### REMARKS

Version with Markings to Show Changes Made."

FIGURE 2

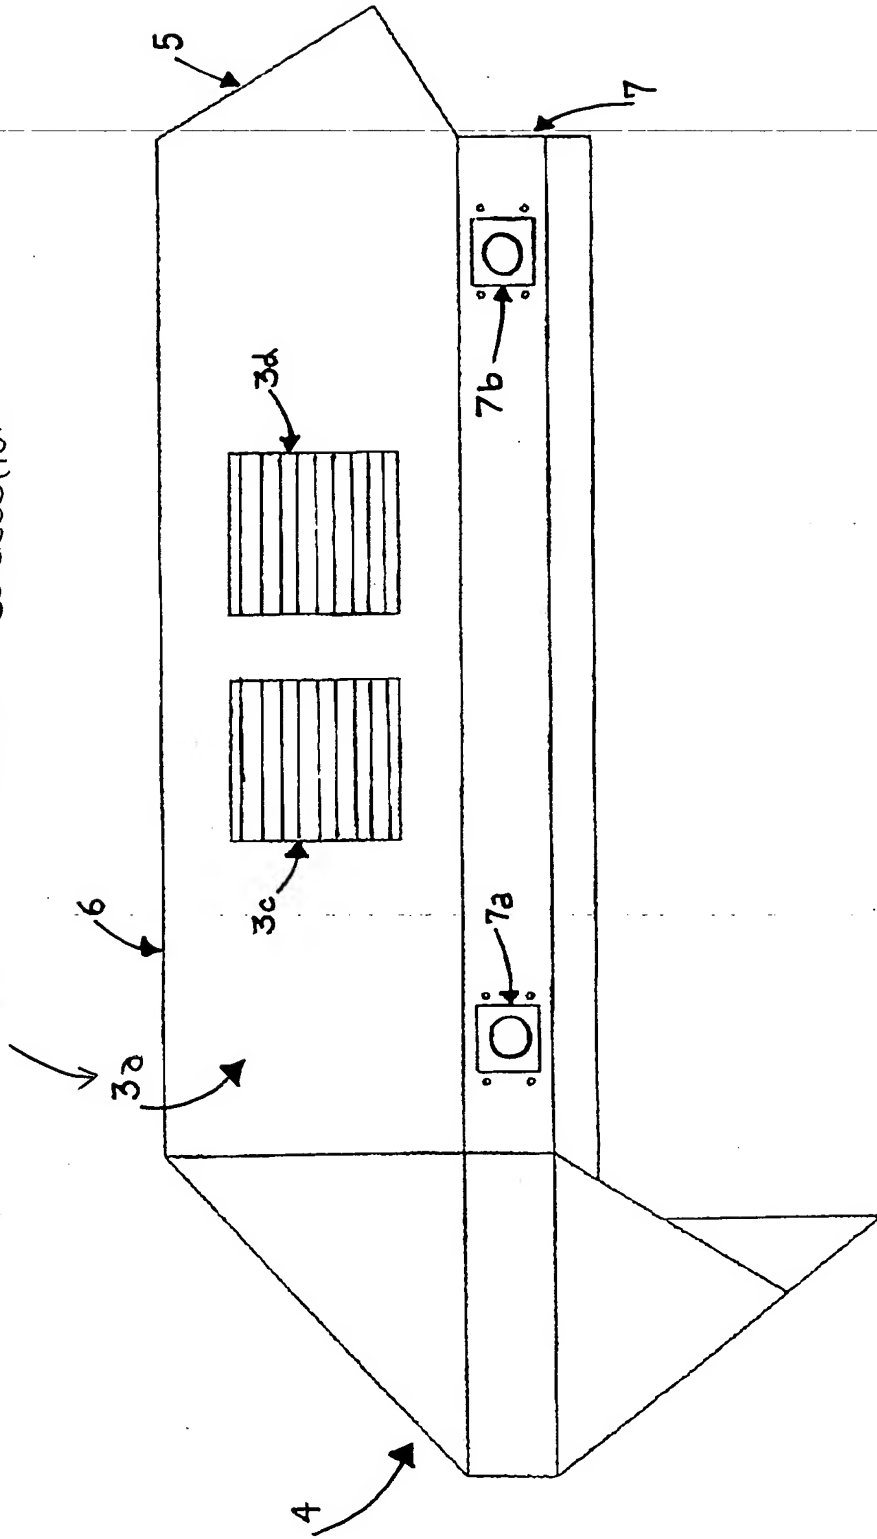
Applicant proposes to make Drawing Corrections to Figures 2, 3(d), 5(c) and 6 to insert omitted reference numbers.

PROPOSED DRAWING- CORRECTION

FIGURE 3(d)

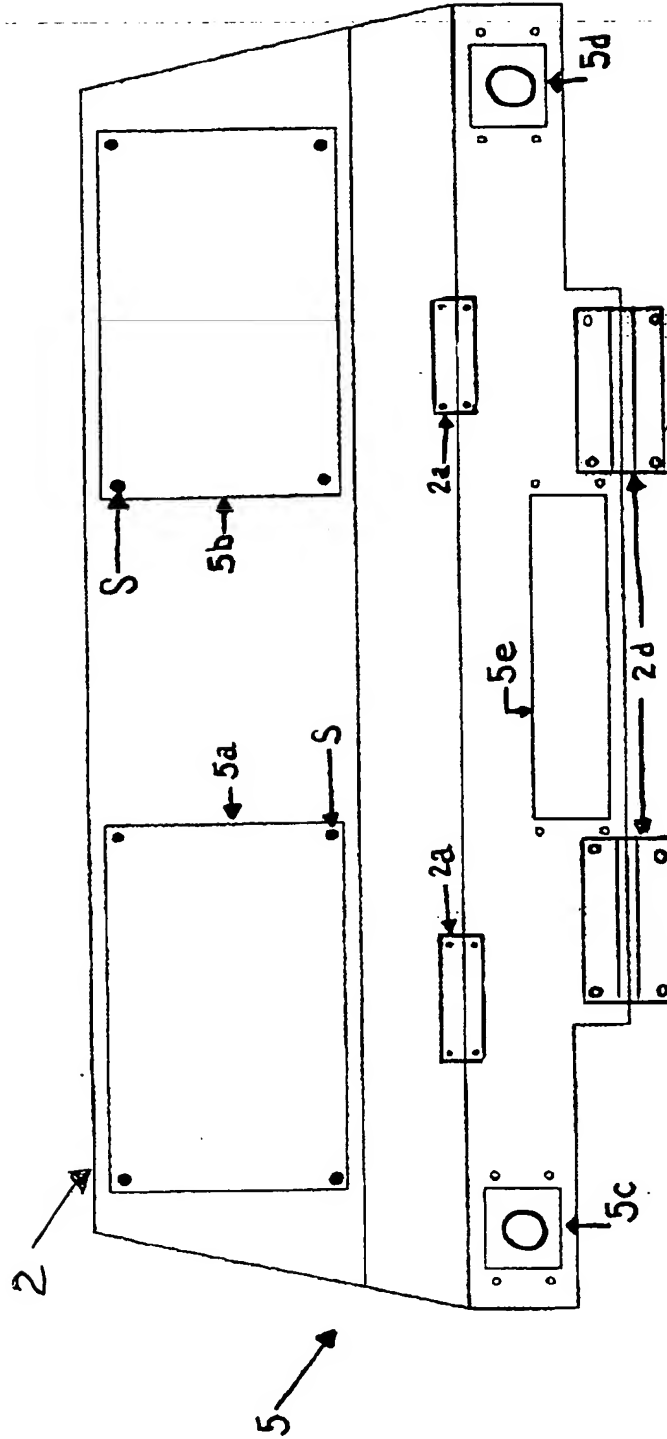
PROPOSED DRAWING-CHANGE

FIGURE 5(C)

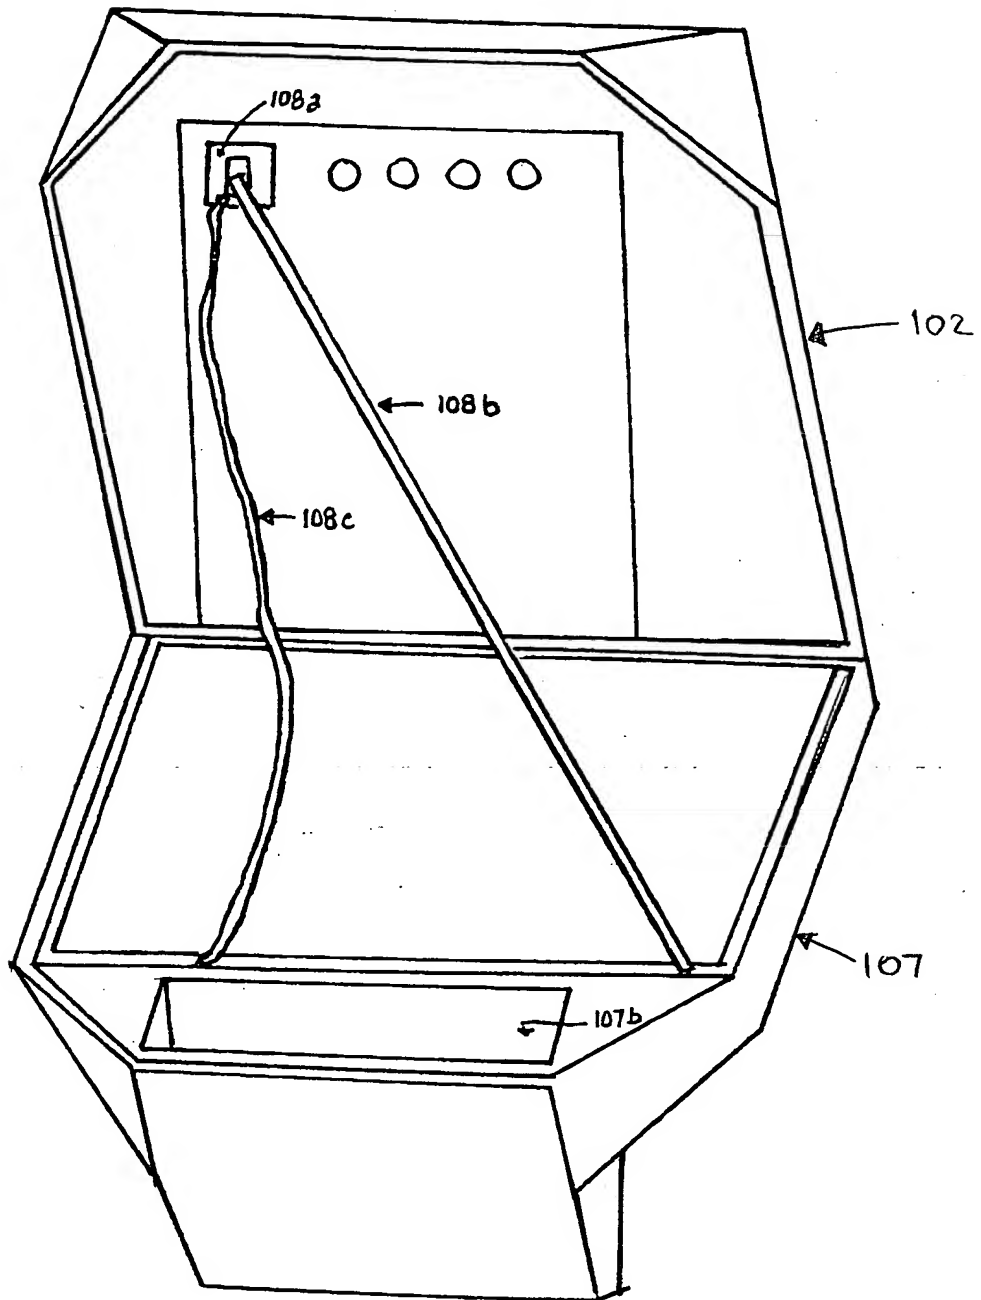
# PROPOSED DRAWING CHANGE
